**ITEM FOR ENVIRONMENTAL COMMISSION AGENDA**

**NAME & NUMBER OF PROJECT:** 1881 Westlake Drive  
SP-2021-0349D

**REQUEST:** Variance request is as follows:  
Request to vary from LDC 25-8-281(C)(2)(b) to allow the construction within 150-foot of a rimrock Critical Environmental Feature (CEF).

**STAFF RECOMMENDATION:** Staff recommends this variance with conditions, having determined the findings of fact to have been met.

1881 WESTLAKE DRIVE  
**PROPOSED CONDITIONS SITE PLAN**

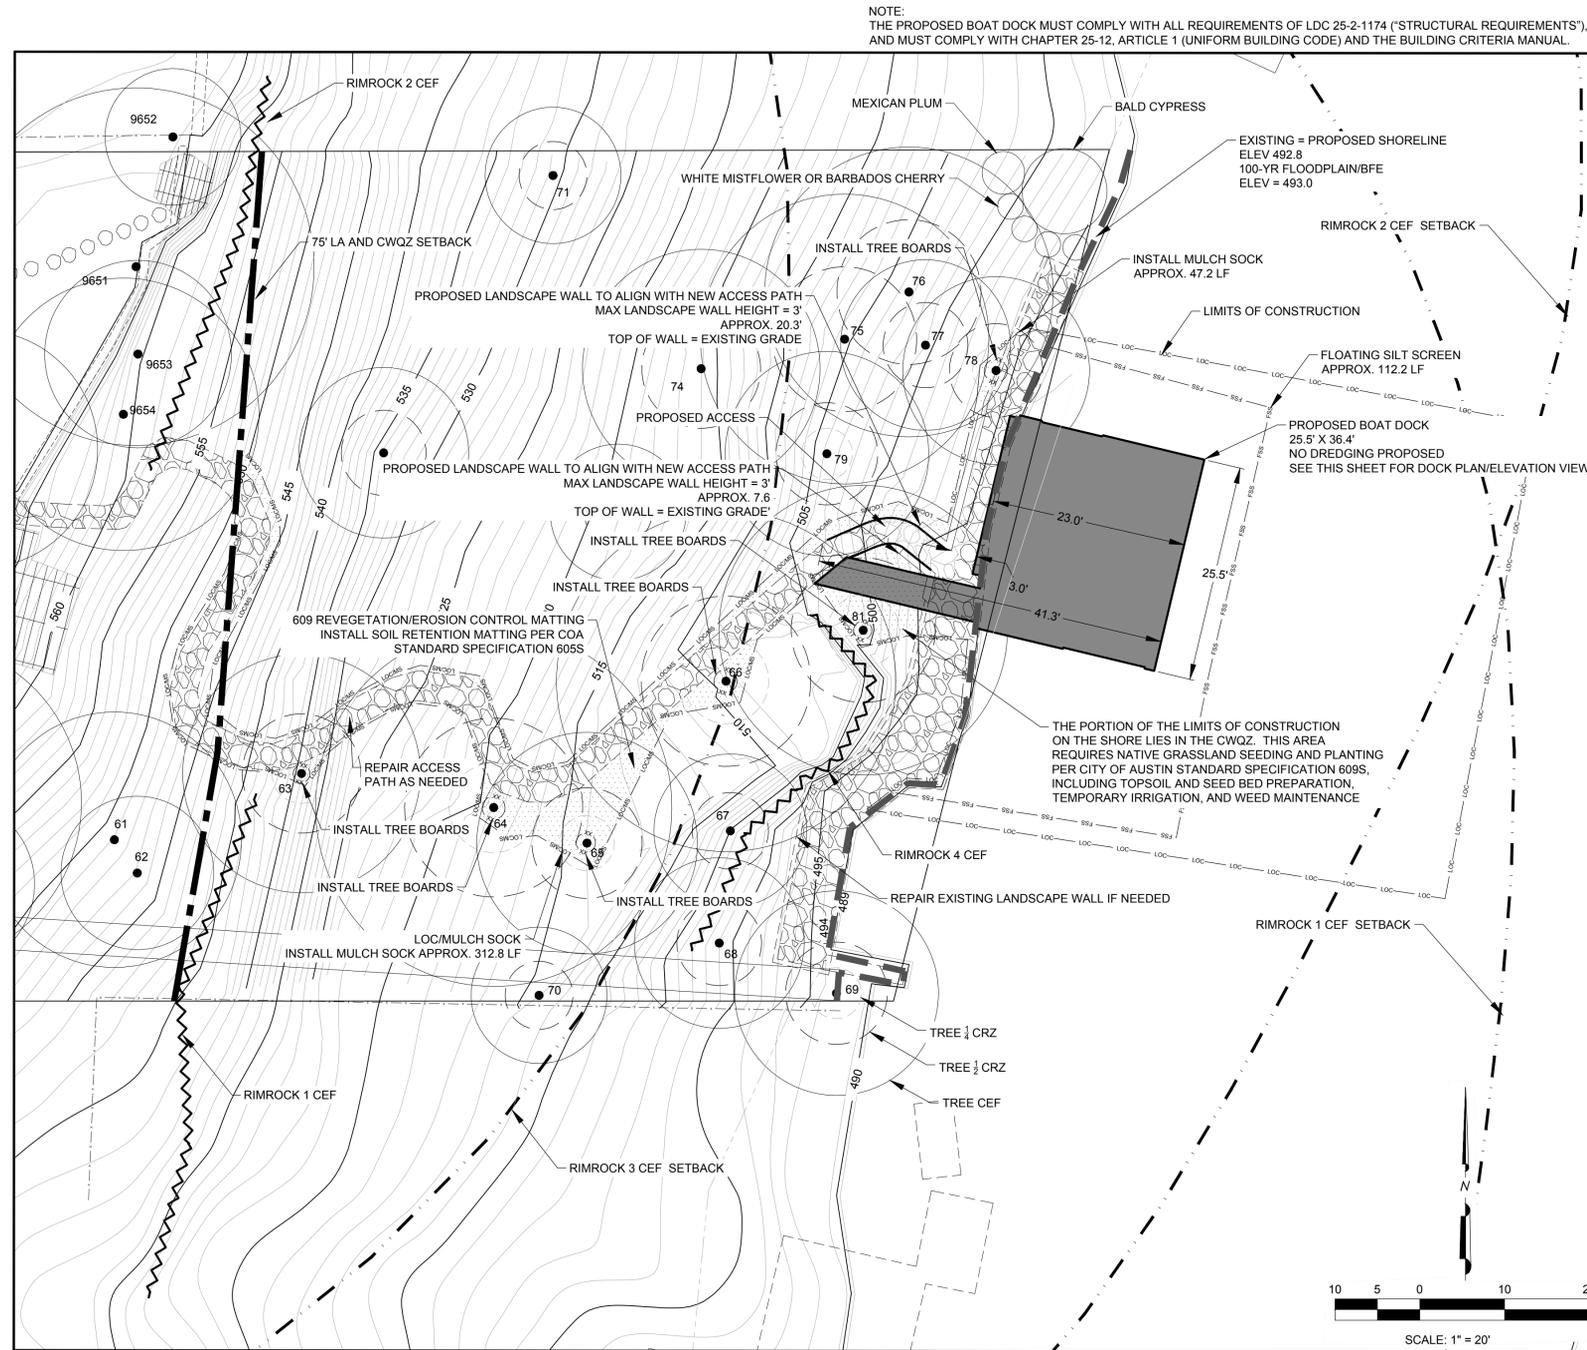
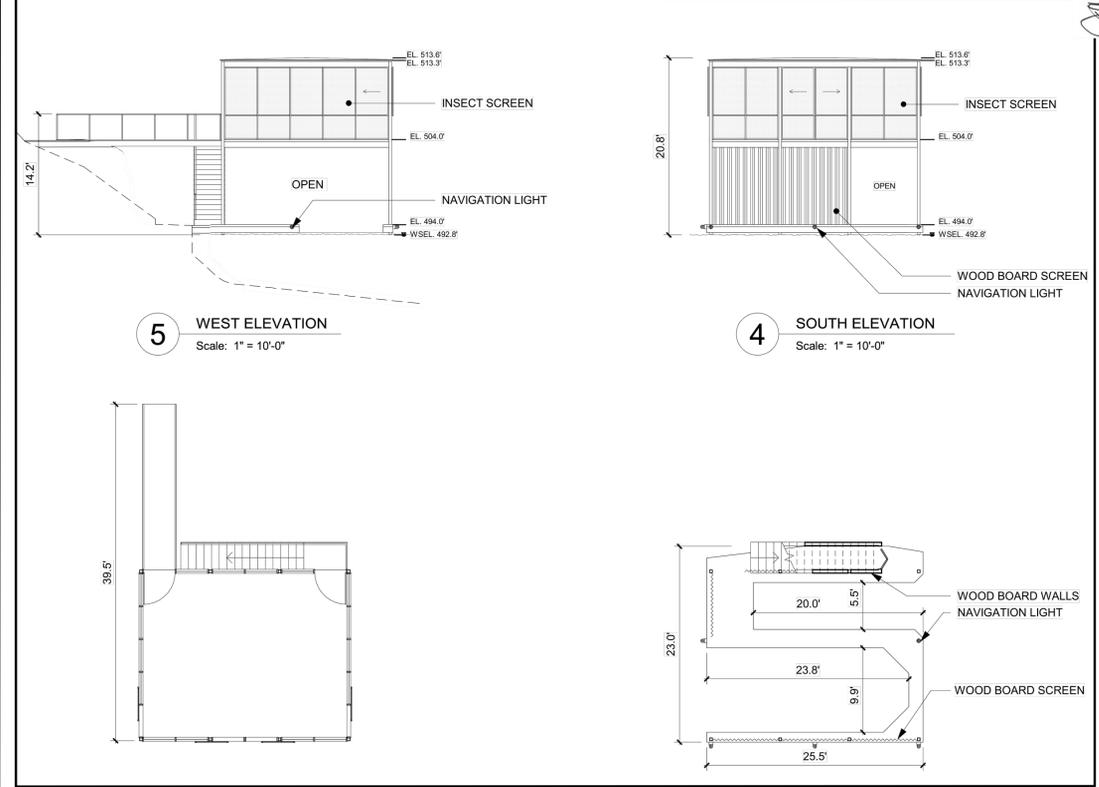
**STAFF CONDITION:** Remove existing boat dock and access path as specified on plans; restore disturbed areas per City Standard Specification 609S. All construction to occur via barge.

**Yes. No disturbance of the rimrock CEF is proposed, all proposed construction activities are to occur downgradient of the rimrock CEFs, and construction is to occur from the lakeside by barge. The proposed construction to be performed from a barge provides greater overall environmental protection.**

**Yes. The variance does not create significant harmful environmental consequences. The construction of the boat dock from barge will not disturb the rimrock critical environmental feature.**
